Job Name: The Old Power Station Vastern Road
Job No: 47500
Note No: TN004
Date: 9th June 2020
Prepared By: Joe House / Dan Townsend
Subject: RBC Highway Response

This technical note has been prepared by Stantec on behalf of Berkeley Homes (Oxford and Chiltern) Ltd to provide a response to Reading Borough Council (RBC) highway comments provided in the letter dated 28th May 2020.

The comments provided are in response to the full planning application (ref. 200188) for the demolition of existing structures and erection of a series of buildings ranging in height from 1 to 11 storeys, including residential dwellings (C3 use class) and retail floorspace (A3 use class), together with a new north-south pedestrian link, connecting Christchurch Bridge to Vastern Road.

drawing
LANDSCAPE GENERAL ARRANGEMENT PLAN

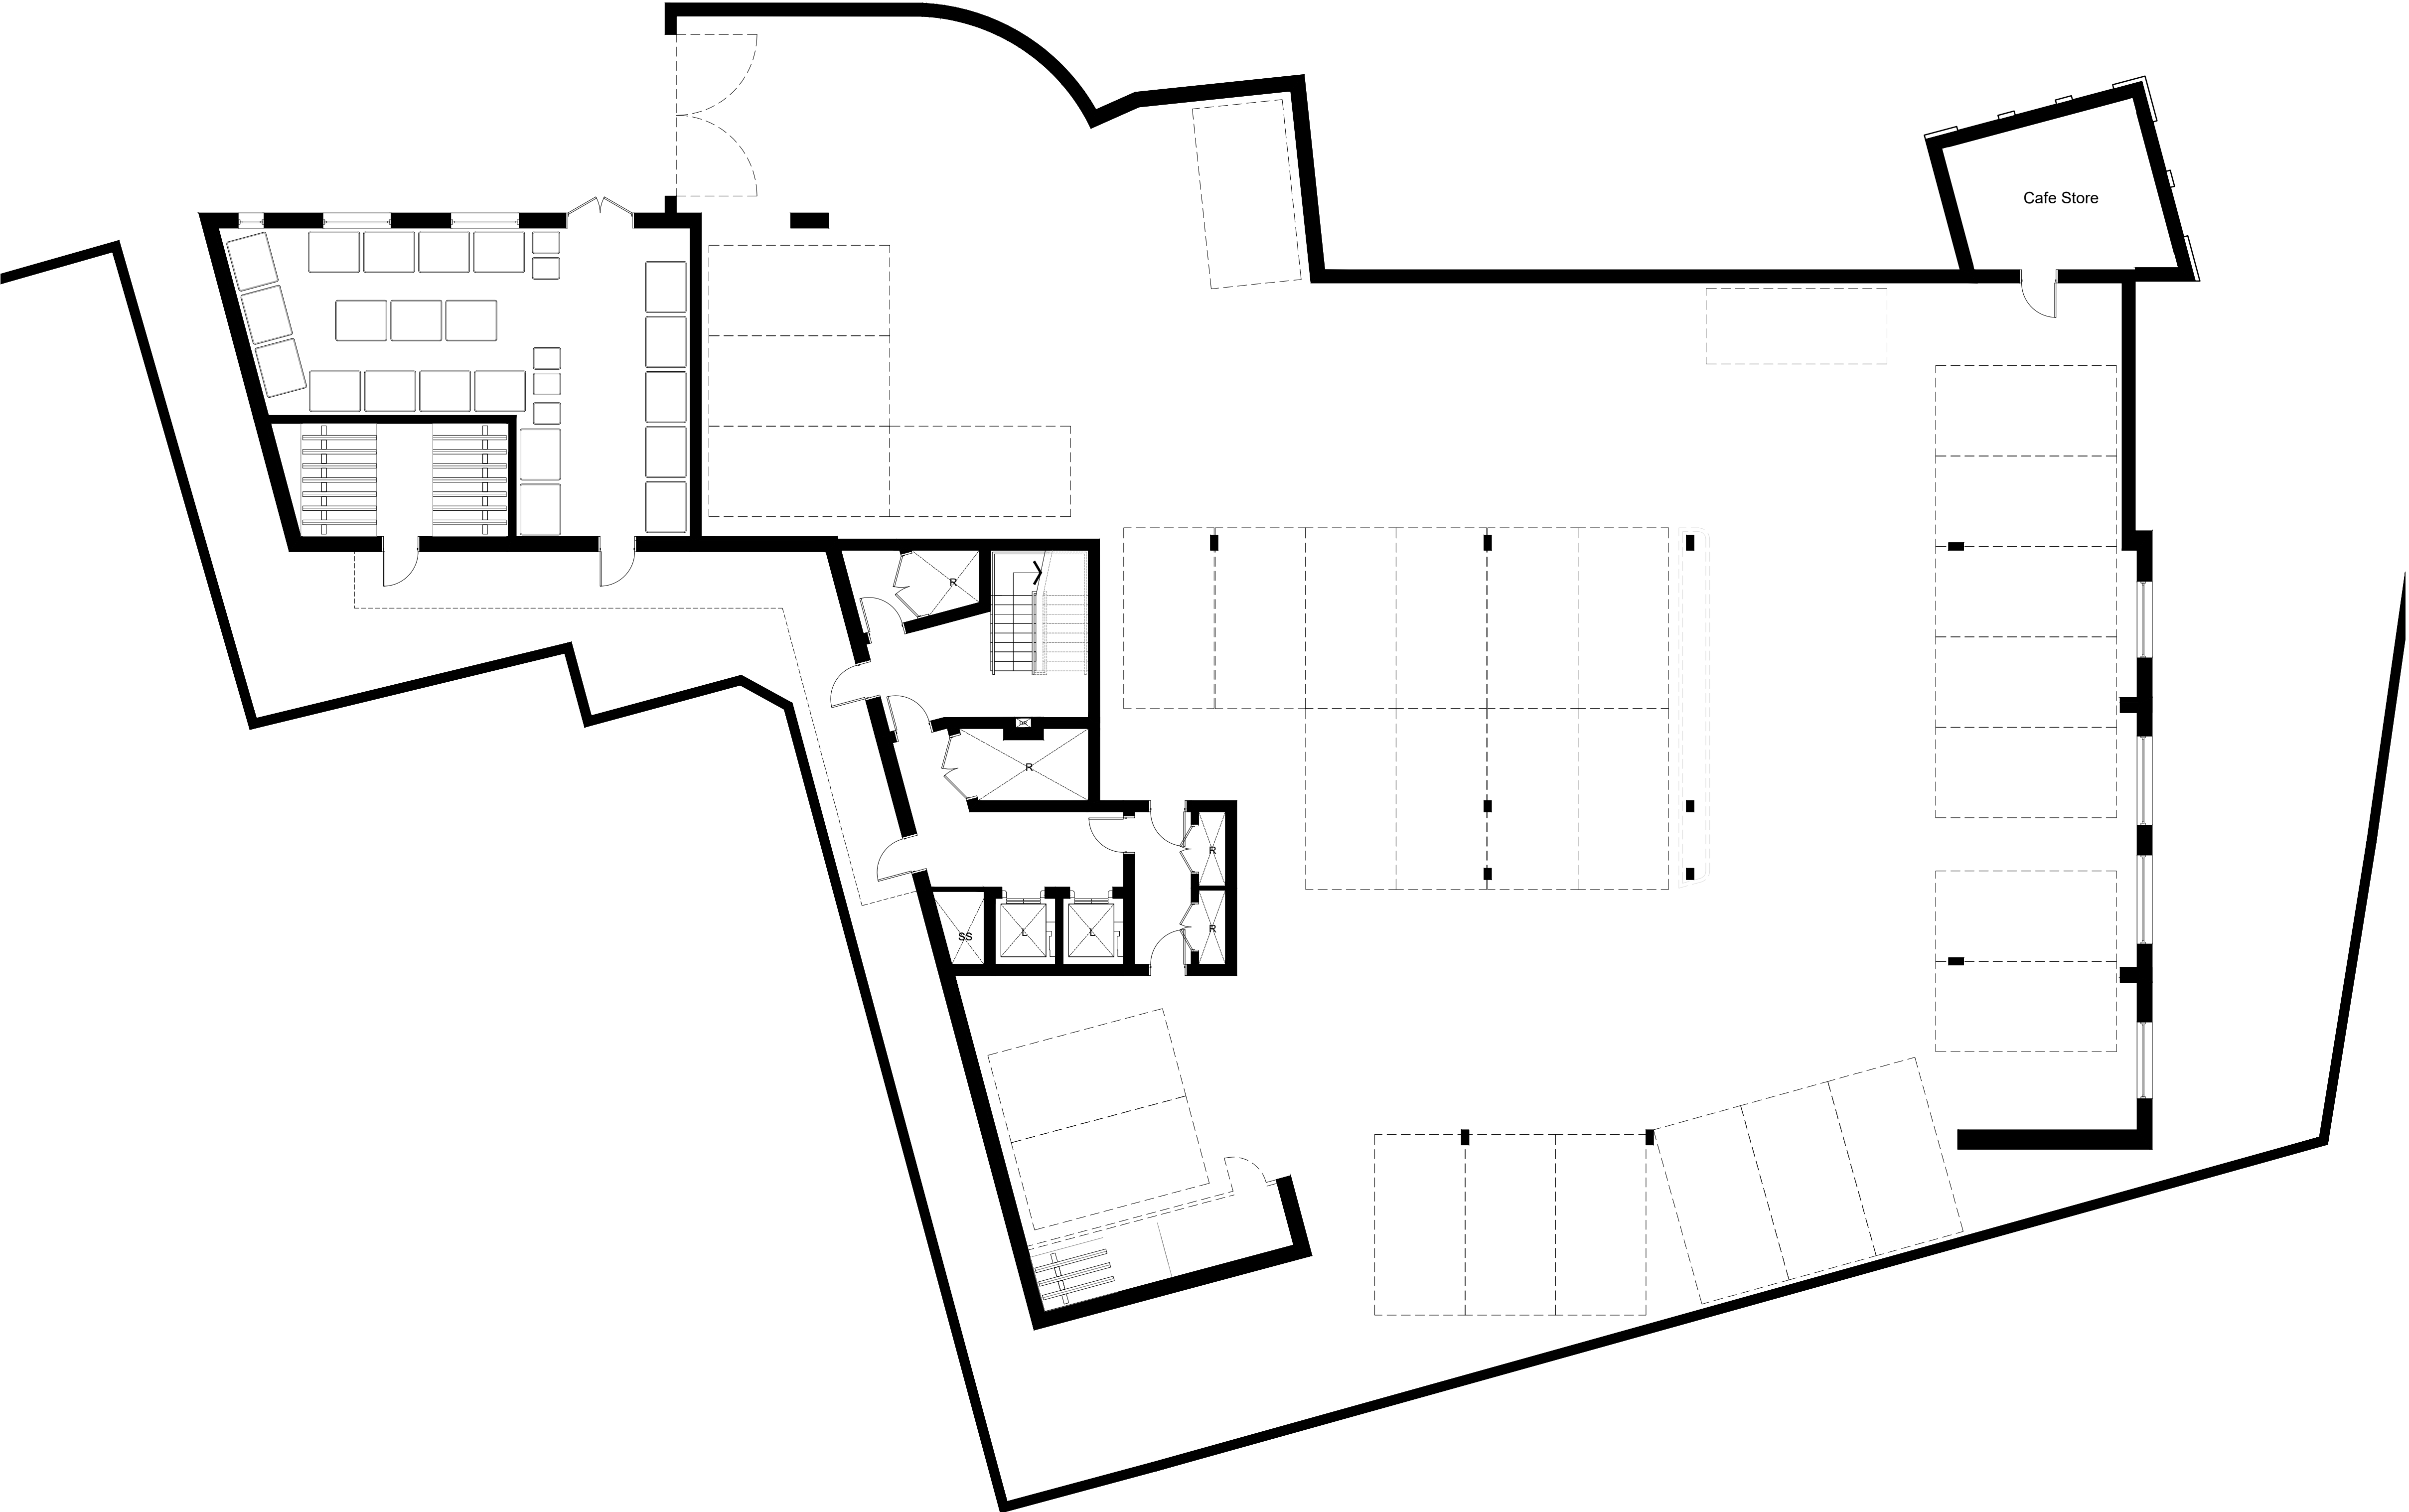
- b) *“It is noted that along the southern boundary of the Coal Drop Building an east west path is provided that circumvents the building, however this path should be extended further east to connect to the north south route given that residents will wish to use this as this will be a desire line. The scheme should be revised to provide this link.”*

- a) *“Tracking diagrams have been provided that identify that two cars can pass one another however it is noted that the tracking for a refuse vehicle and a HGV would require the use of the full width of the carriageway not only through the site but also on Lynmouth Road. This is for a distance in excess of 50m whilst also negotiating two 90 degree bends, this will therefore result in conflict between cars and service vehicles as well as vehicles with pedestrians and cyclists using the north – south footway / cycleway. The proposed scheme therefore does not accord with DfT document Manual for Streets...”*

- b) *"It is noted that the road markings at the entrance of the site are to be provided away from the kerb line with no justification provided. On review of the drawings it would appear that this has been provided to widen the access to allow two cars to pass one-another at the site access. This is not acceptable and the give way marking must be provided along the kerb edge..."*

"It is also noted that no tactile paving has been illustrated on the submitted drawing, given that the proposal now takes the form of a bellmouth this must be provided"

A revised masterplan has been prepared which provides a footpath linking the primary north-south shared foot/cycleway to the rear of the Coal Drop building.

The recommendation provided by RBC with regards to alignment of the give way markings and tactile paving have been incorporated into the site access design proposals.

drawing
Block D
Ground Floor Plan

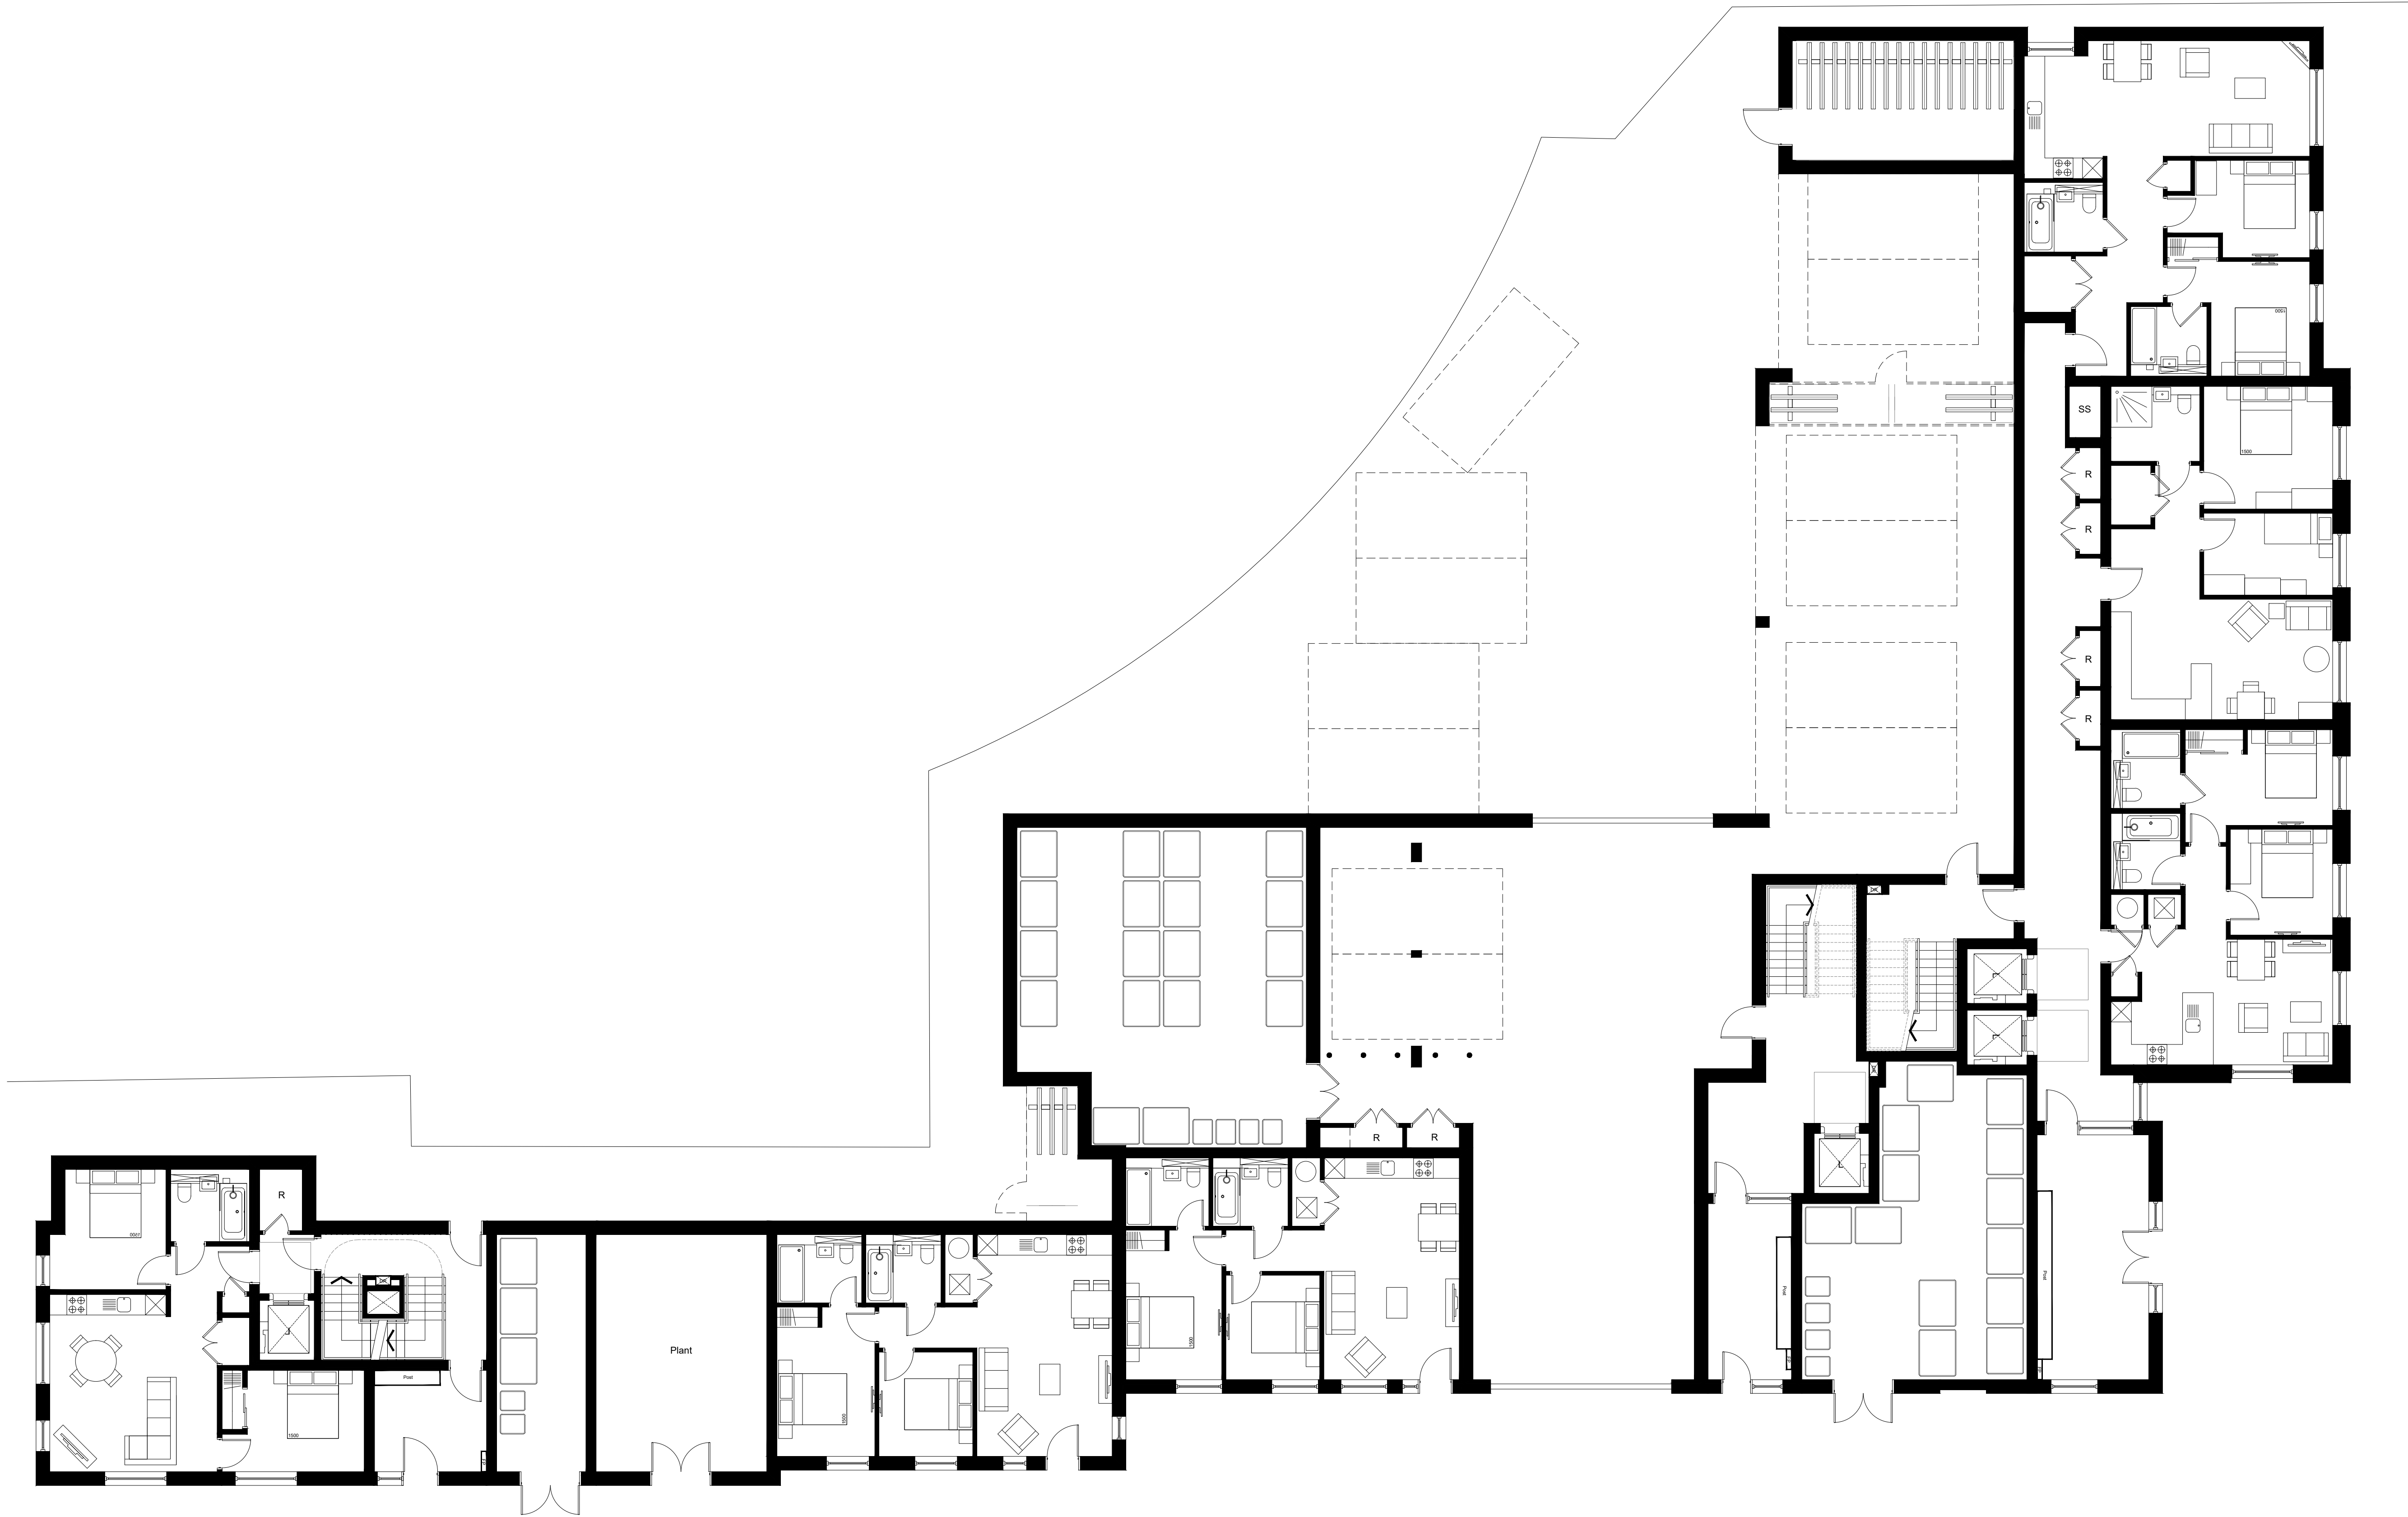
- b) *"I also have concern regarding the location of two of the cycle stores, the first being that for Block D given that this is accessed from the rear of the site and is therefore not convenient or inviting. The store is also not very well overlooked and could be the subject of crime. The cycle store must therefore be relocated to a more convenient location."*

The masterplan and cycle parking provisions have been modified to reflect the above requirements for Buildings B and D. The revised building floor plans for B and D are contained within **Appendix A**.

A 10.06.20 EE Added cycle store in the undercroft
